**Memorandum  
Community & Economic Development Department**

**To:** Thomas Thomas, City Manager  
**Subject:** Riverfront Overlay District Site Plan Review Request for  
4501 47<sup>th</sup> Avenue Court  
**Date:** September 8, 2014

Subject: Case #2014-6 Review of Riverfront Corridor Overlay District Final Site Plan  
Review at approximately 4501 47<sup>th</sup> Avenue Court.

Total Sign Area =144.5Sq. Ft.

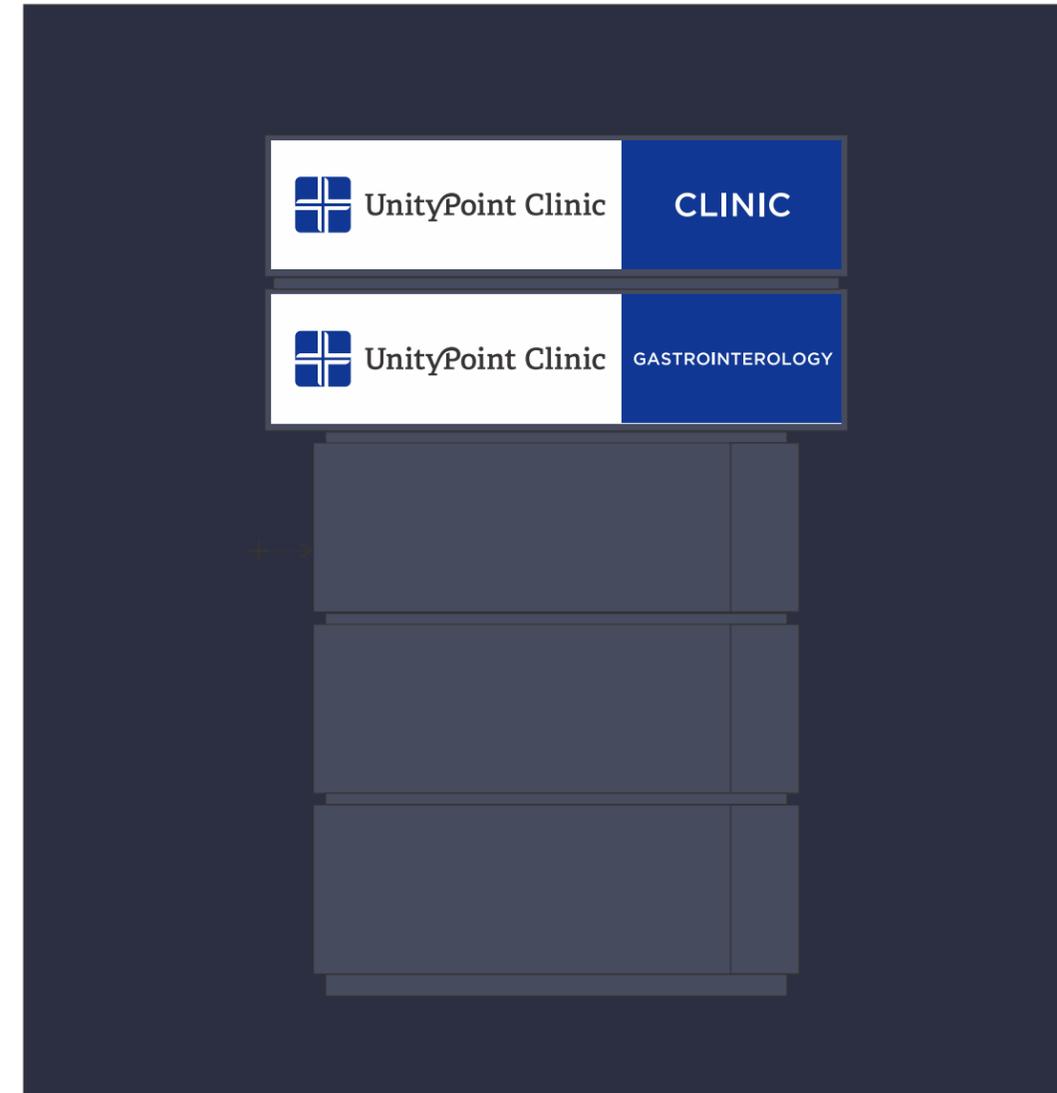
The applicant proposes two freestanding signs for the development. There will be a 144.5 square-foot site identification sign located at the northwest corner of the site (intersection of 47<sup>th</sup> Avenue Court and 45<sup>th</sup> Street Court). This sign will be located 25 feet from the north and west property lines. The sign will have two panels identifying the clinic and medical offices (see attached sign drawing). Total height of the internally lit sign will be 25 feet from the finished grade to top of sign (B-4 zoning allows up to a 25-foot total freestanding sign height).

Total Sign Area = 15 Sq. Ft.

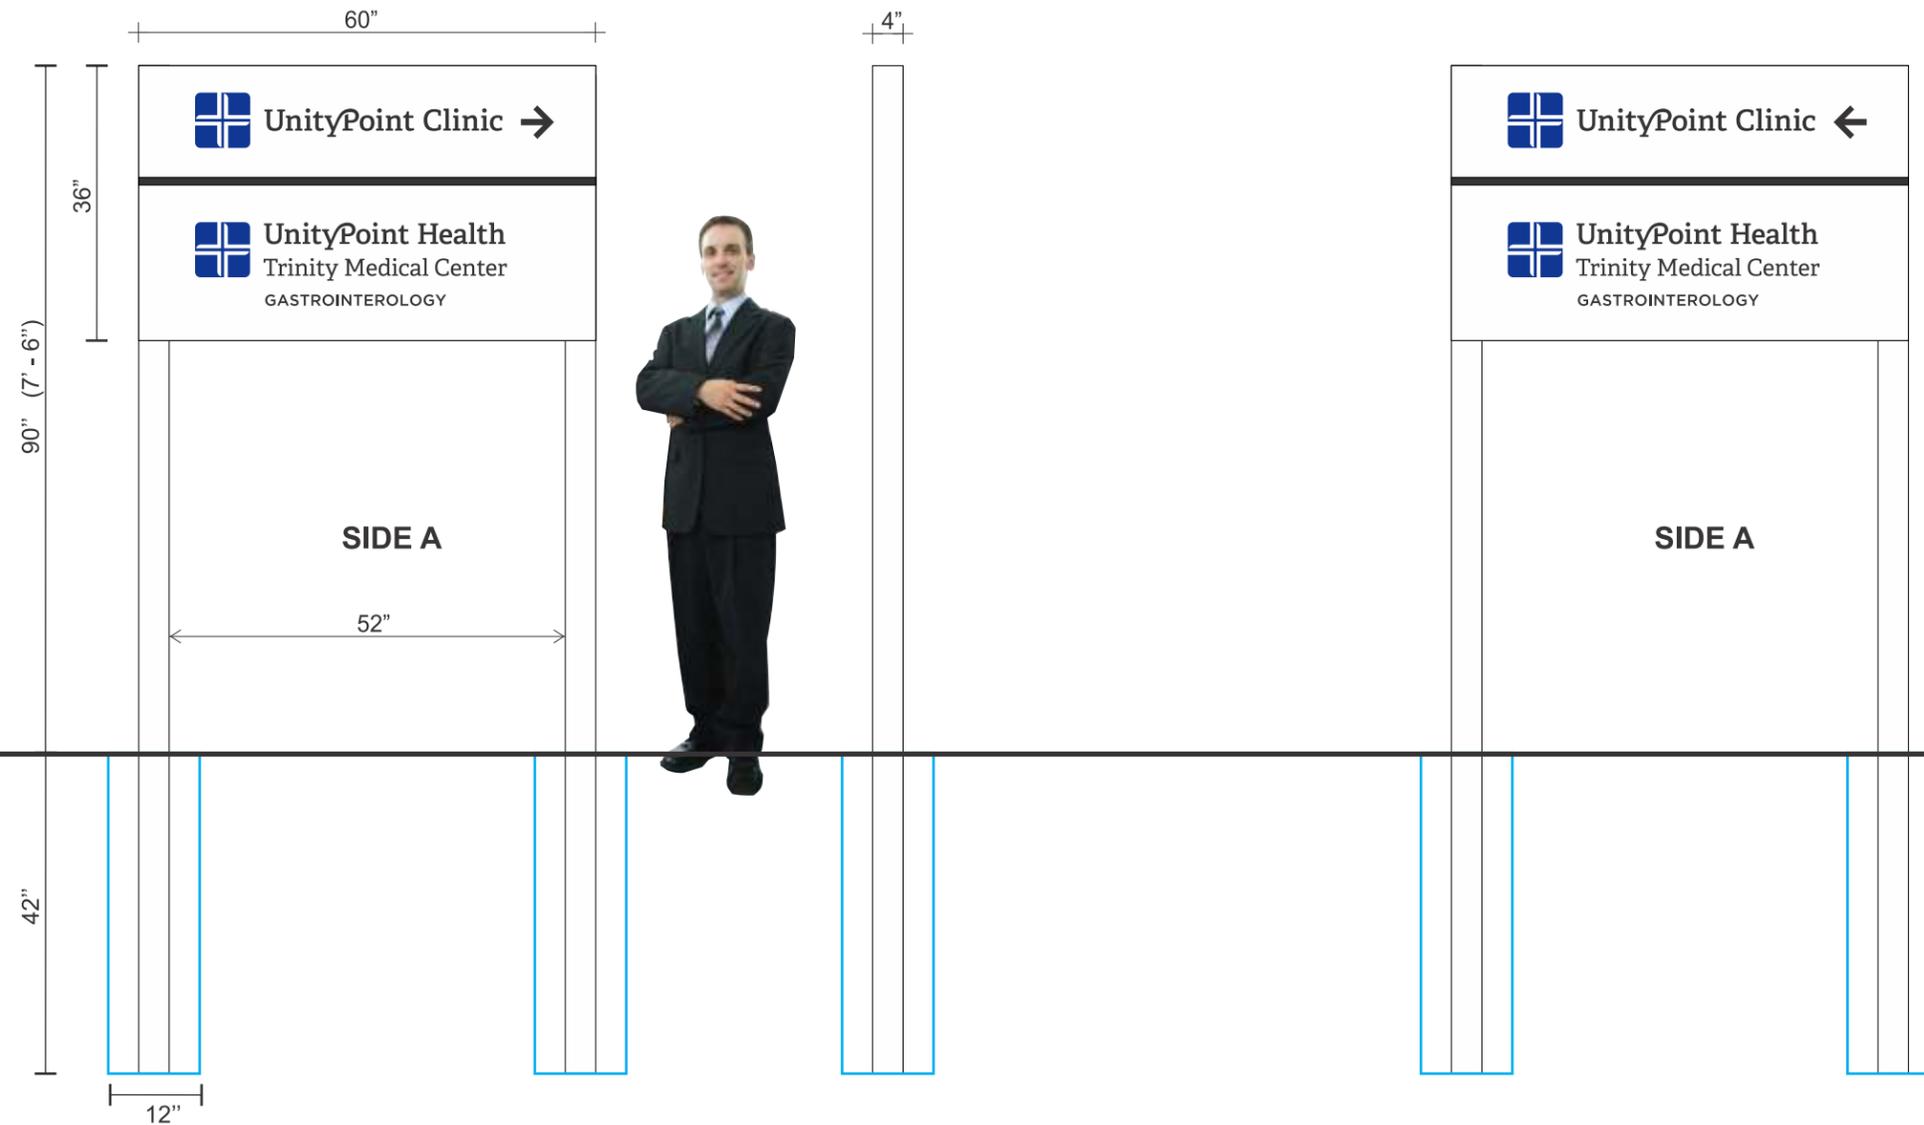
The second freestanding sign will serve more as a directional sign and will be located north of the 45<sup>th</sup> Street entrance and will be approximately 25 feet from the west property line. The sign will have a total area of 15 square feet and a height of 7’ 6” from grade to top of sign.

Site Lighting  
% TCE

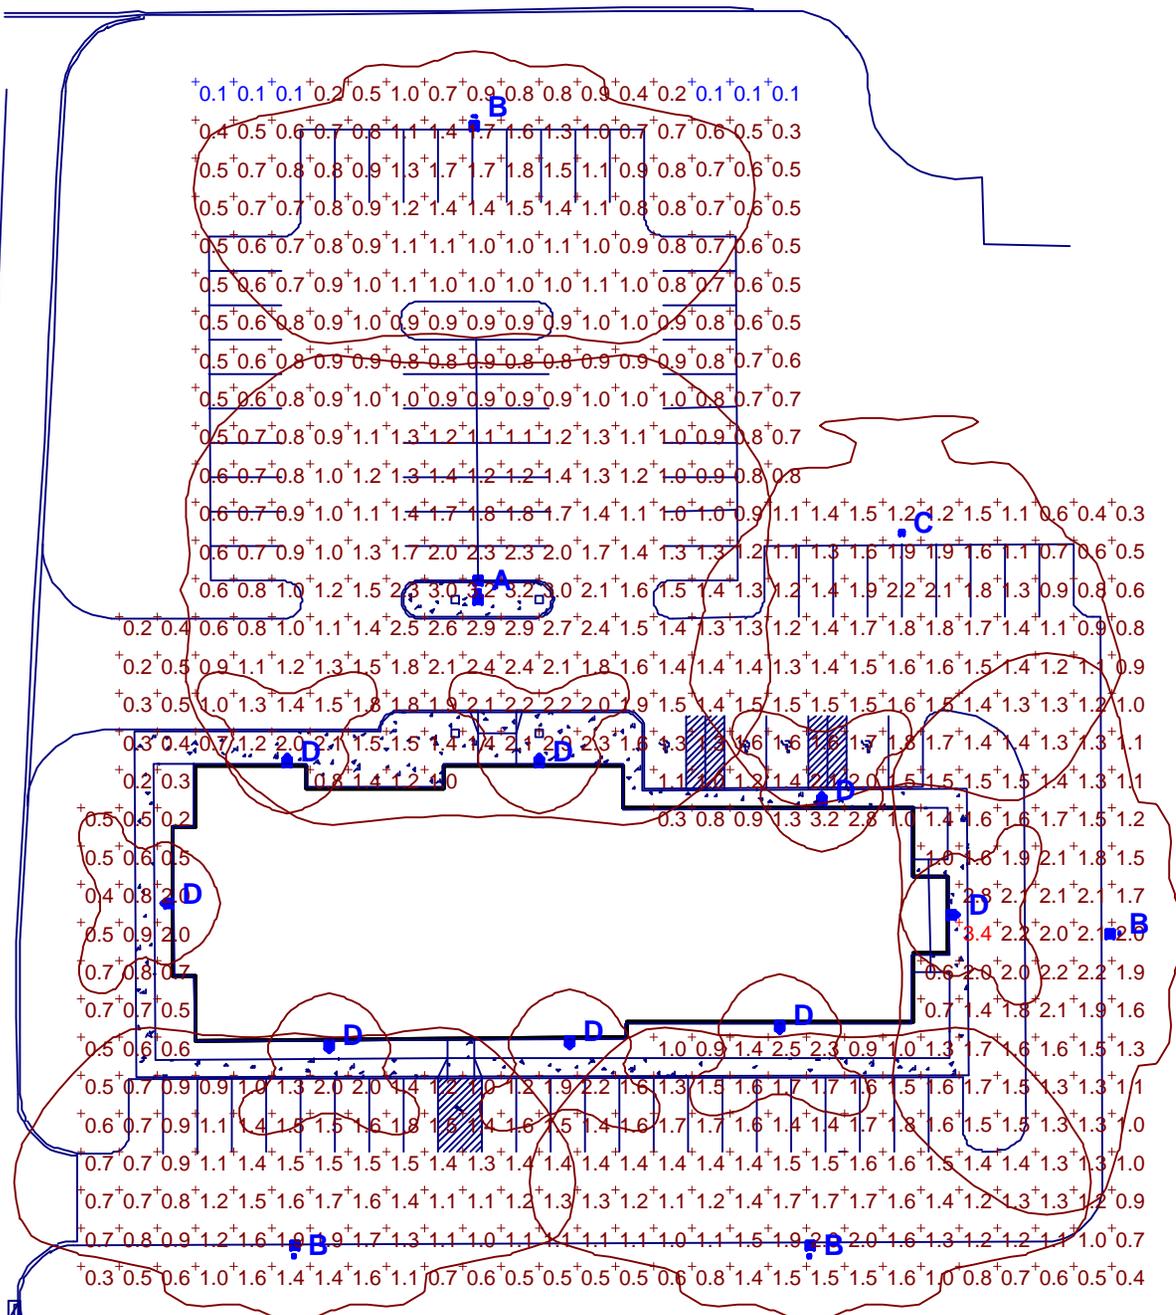
This area will have “street” light standards to light the parking and private drive. The attached “site lighting” map identifies that the foot-candle level of these light standards exceeds the ordinance requirement of one foot-candle at the south property line. This requires a variance. Staff recommends approval since the area will be used as parking and a shared private drive.

The only variance requested is for the foot-candle lighting level along the south property line adjacent to the private drive. Planning staff recommends approval of this variance.

That the attached final site plan be approved, with the requested variance for lighting along the southern private drive and parking area, because there is adequate parking and access and the proposed use is compatible with adjacent land uses.

# Landscape Plan

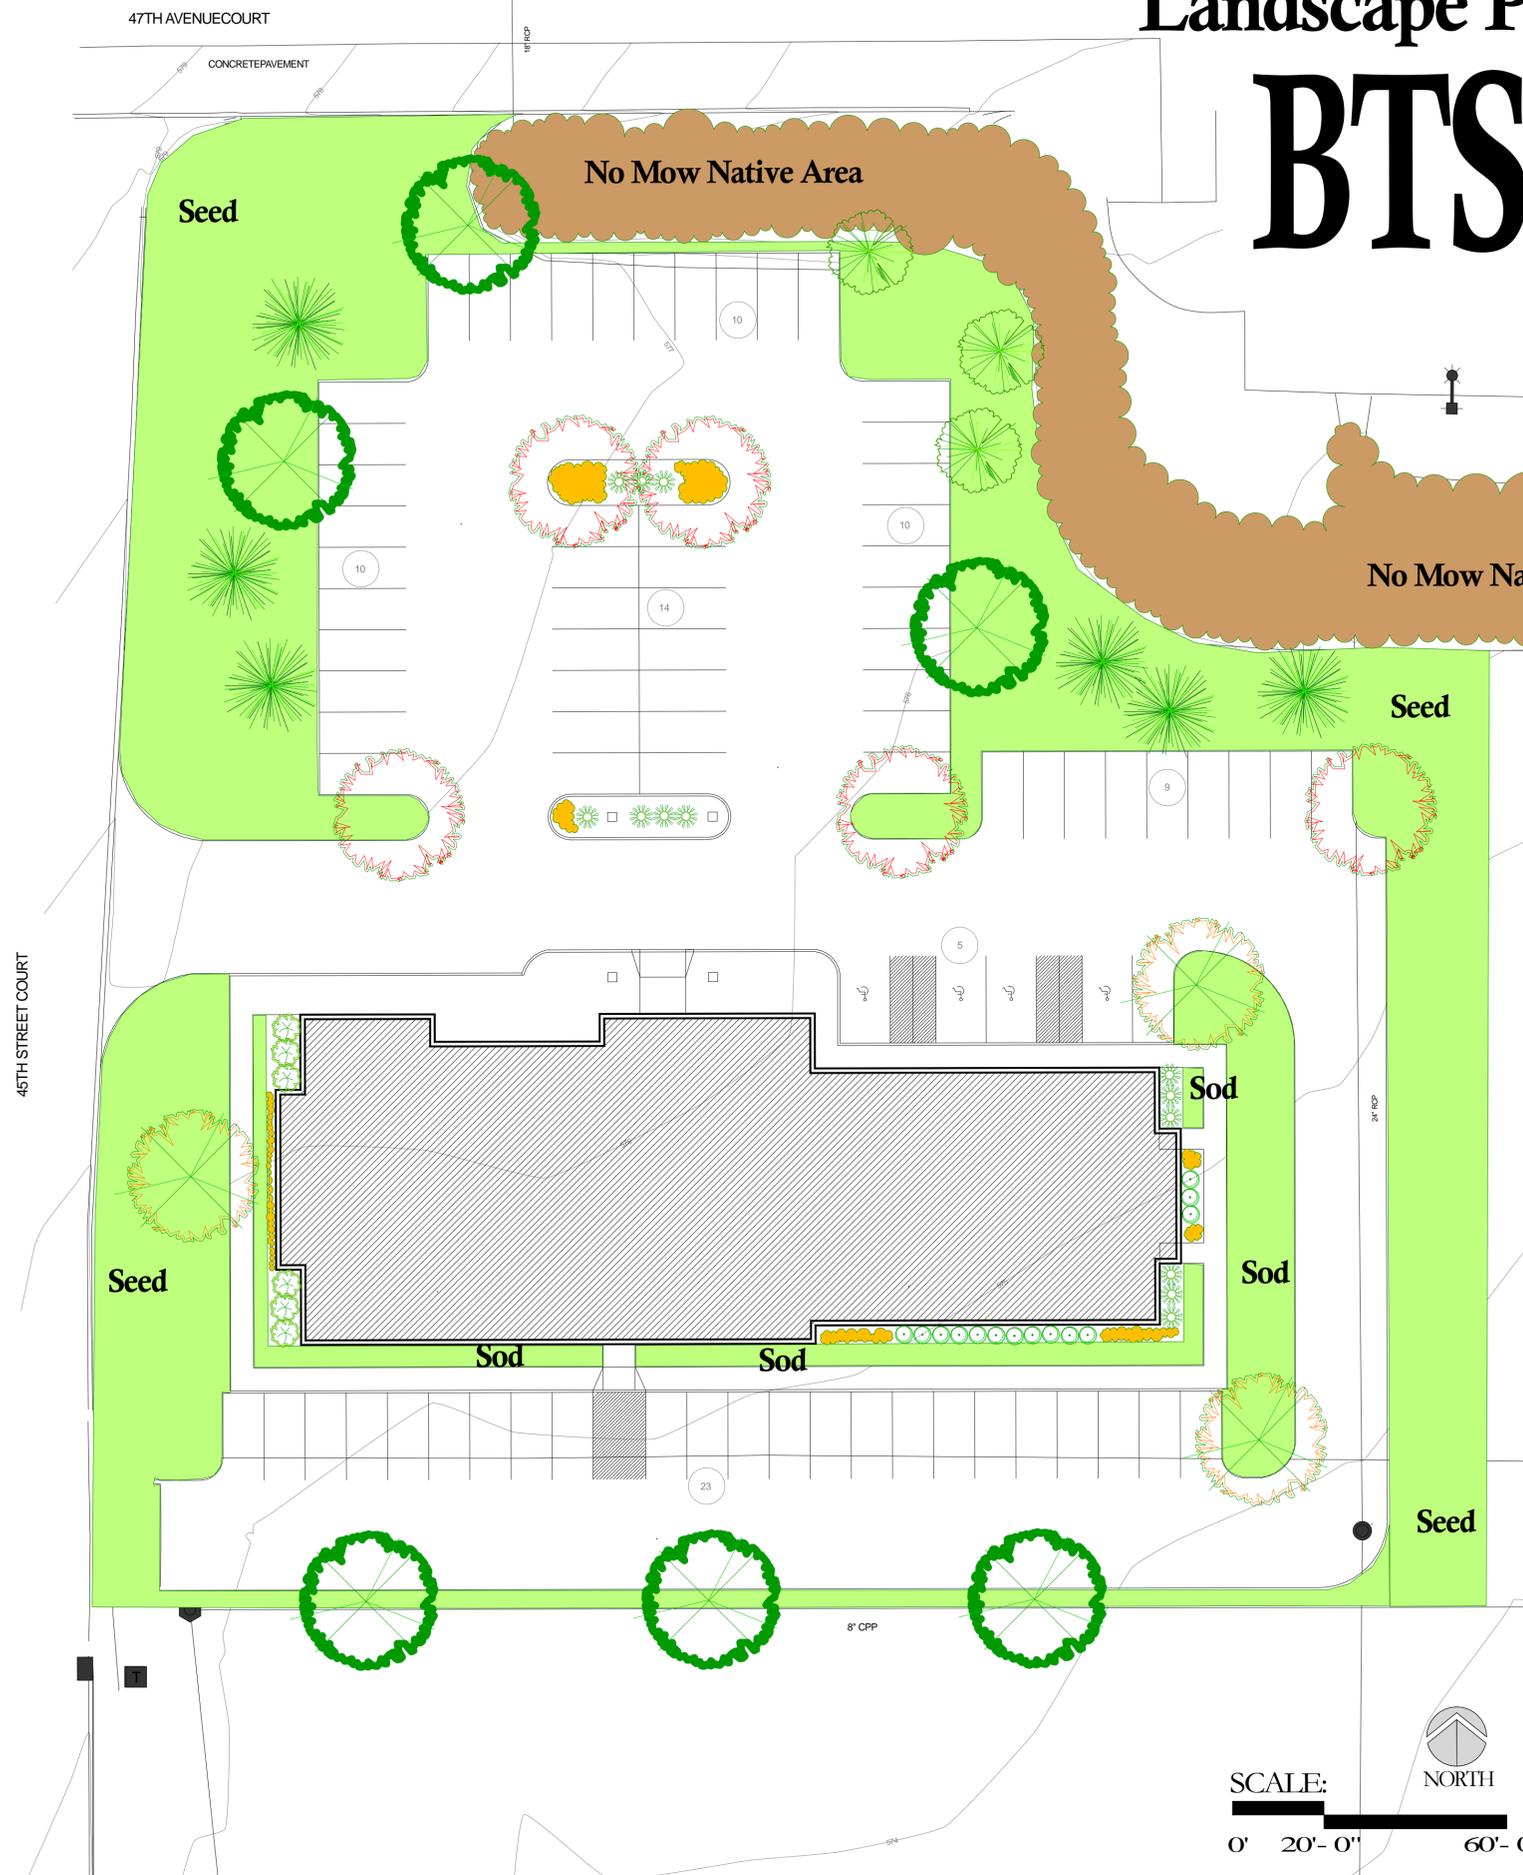
The attached landscape plan identifies an approximate 25 to 30 foot wide landscape area along the north, east and west edges of the parking lot on the north side of the development (see landscape plan). The western edge of this landscaped area includes three white pine and two frontier elm trees. The northern and eastern edge also includes three white pine trees, one frontier elm tree and adds three bald cypress trees to this area. The northern parking lot also includes several landscaped “islands” with red maple canopy trees. Islands are not required by ordinance, but add an attractive landscape addition to the plan. Additional landscaping, not specifically required by ordinance but added around the structure (low level day lilies, blue muffin viburnum and summerwine ninebark shrubs) enhances the attractiveness of the site design.
